**Proposal to P2600 meeting #20, Camas WA  
 Brian Smithson, Ricoh Corporation, 6/16/06**

**Introduction**

This proposal deals with differences between PP-A and PP-B and also deals with some inconsistencies among threats and objectives related to protecting data that is stored on the HCD.

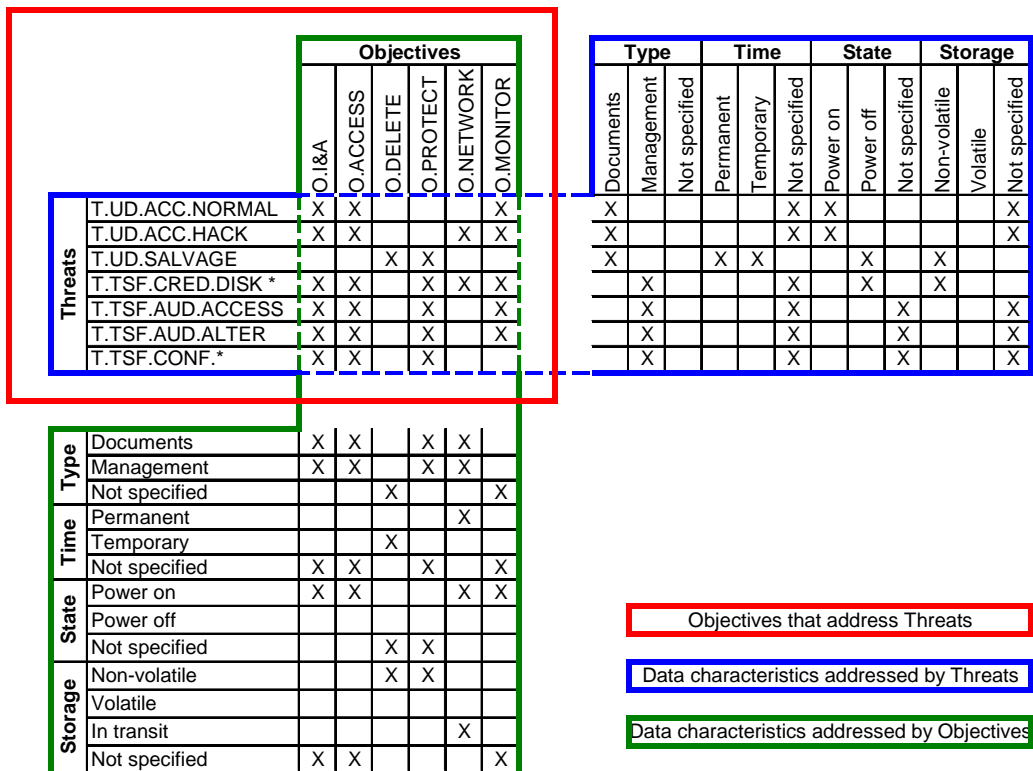
The chart, below, contains threats and objectives related to protecting data stored on the HCD. There are three outlined areas:

- The red area is a subset of P2600 threats and the objectives that are employed to address those threats.
- The blue area shows the characteristics of the data addressed by each threat, according to how those threats are currently specified.
- The green area shows the characteristics of the data addressed by each objective, according to how those objectives are currently specified.

Objectives are for T.TSF.CRED.DISK|NET|EM|GUESS|MGMT

From this chart, you can see what kinds of data are addressed by each threat and by each objective. It may be useful in the discussion of some issues.

Here is a new chart representing these changes, marked in yellow:

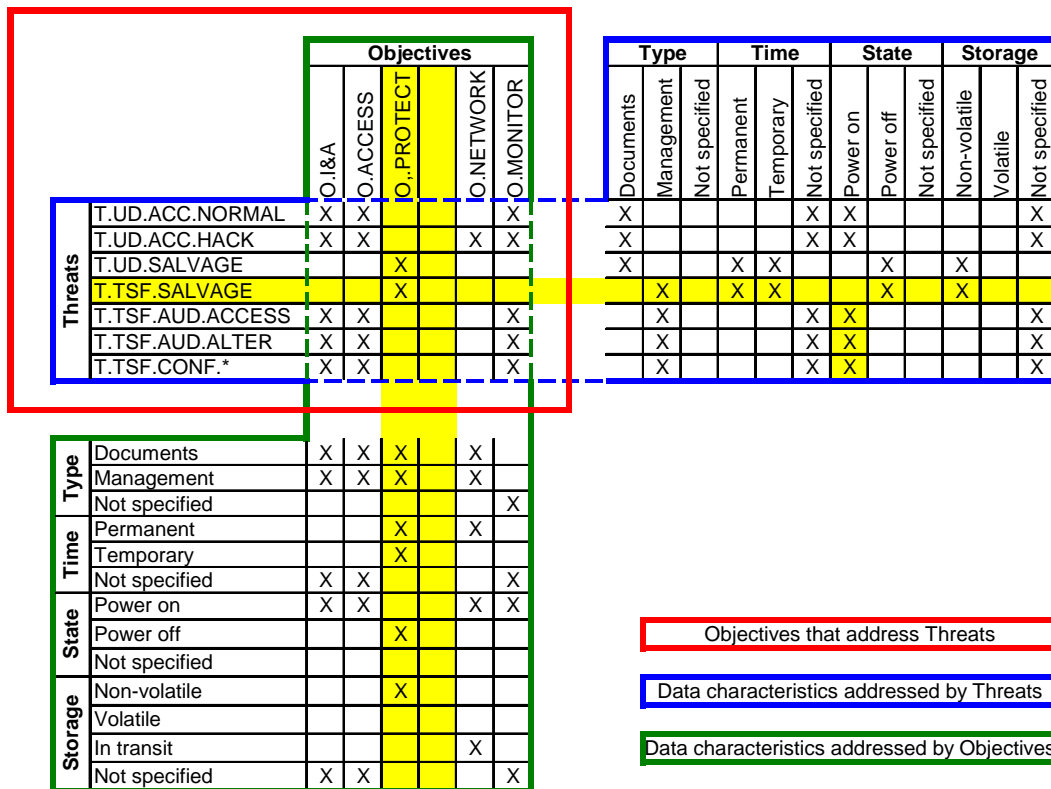
- Replace T.TSF.CRED.DISK with T.TSF.SALVAGE and expand its scope to include both Management Data and User Function Data.
- Change the objective of O.PROTECT to prevent unauthorized access to data on non-volatile storage devices when disconnected from the TOE.
- Remove O.DELETE. It is adequately covered by O.PROTECT.
- Remove O.PROTECT from the list of objectives for all threats except T.UD.SALVAGE and T.TSF.SALVAGE.
- Rely on O.I&A and O.ACCESS to mitigate T.UD.ACC.\* , T.TSF.AUD.\* , and T.TSF.CONF.\*.
